# SERVICE BULLETIN No. 292 72 2239

**Subject:**  
Module M01 - Magnetic seal assemblies installed on starter gear.  
Modification of the preformed packings.  
Modification TU 239.

**Figure 1**

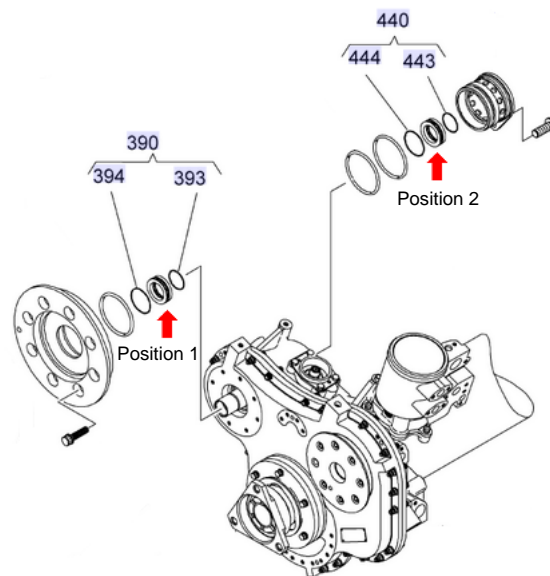
Operators of ARRIEL 2 engines found oil leaks on the magnetic seal assemblies Position 1: seal of the Dynastart adapter and Position 2: seal of the breather cover (see figure 1) installed on the starter gear of the accessory gearbox module (M01).

The investigations done by Safran Helicopter Engines on the magnetic seal assemblies Position 1 and Position 2 highlighted damage to preformed packings linked to premature aging. It was also shown that the material of the preformed packings was not optimum when these seals were used in a HTS (High Thermal Stability) oil environment.

Items 390 and 440 of magnetic seal assemblies  
 Items 393, 394, 443 and 444 of preformed packings

Modification TU 239 introduces new preformed packings in the magnetic seal assemblies Position 1 and Position 2 made from material compatible with HTS oils.
